SECOND PUBLIC REVIEW DRAFT
2027 NATIONAL FUEL GAS CODE (Z223.1)

National Fuel Gas Code

2027 Edition

SECOND PUBLIC REVIEW DRAFT

Figure 10.25.2.25
Installation of Type B-W gas vents for w
vented wall furnaces.

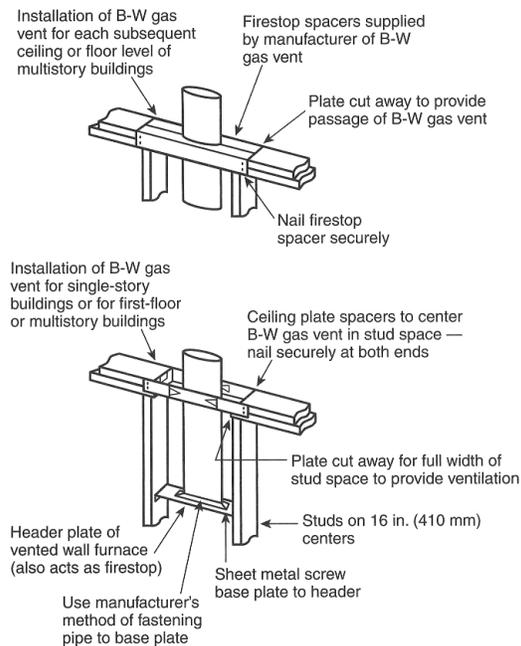
10.25.2.4 Type B-W gas vents shall be attached directly to a solid header plate that serves as a firestop at that point and the solid header is that shall be permitted to be an integral part of the vented wall furnace, as illustrated in Figure 10.25.2.25.

10.25.2.5 The stud space in which the vented wall furnace is installed shall be ventilated at the first ceiling level by installation of the ceiling plate spacers furnished with the gas vent.

10.25.2.6 Firestop spacers shall be installed at each subsequent ceiling or floor level penetrated by the vent.

[SR No. 26-NFPA 54/Z223.1-2024]
